HGY/2023/3404

HGY/2024/0989

HGY/2024/1194

#### **HGY/2024/0989**

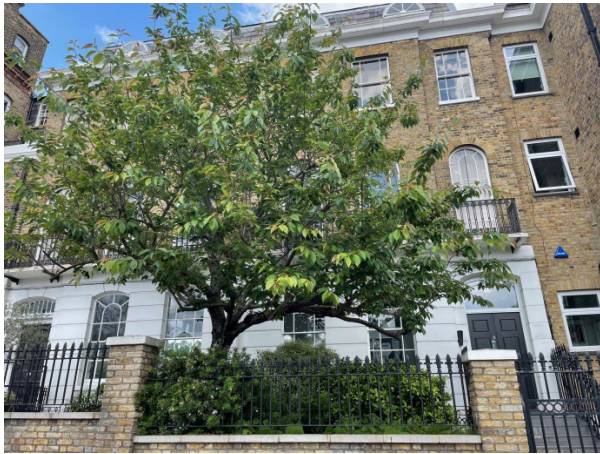
I would like to see more detail on the step free access railing, which looks utilitarian in the drawings. The balconies of the two houses have attractive railing which could be reflected in the proposed design.

There should be further detail on the proposed glazing. I can see that frosted and reflective glazing has been installed already. Will this be replaced like for like, or will they revert to something more in keeping with the original glazing?

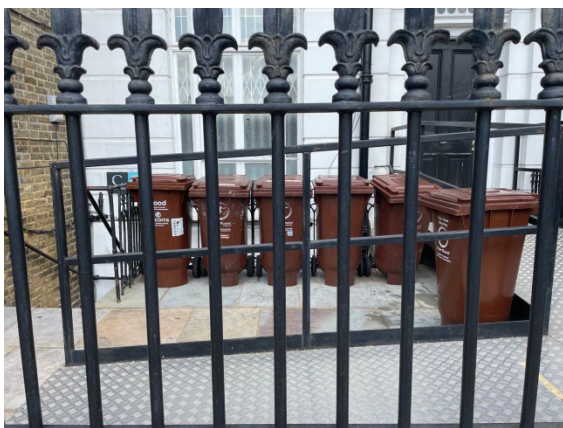
The landscaping proposals, in our opinion, are inappropriate. There is little planting on that part of the road, but the cherry makes a significant contribution to the visual amenity of the street scene, as does the planting at Slingley and the planting in pots at Westfield. The cherry is really appreciated in spring, when it flowers, and at Christmas, when the school puts up lights.

It is unclear whether the cherry tree will be retained. In the DAS the Proposed Landscaping shows it as being retained, but drawings for the Proposed Front Entrance do not include the tree in its current mature form.

The tree should be retained, the current planting at Slingley should be retained and planting at Westview should match that at Slingley
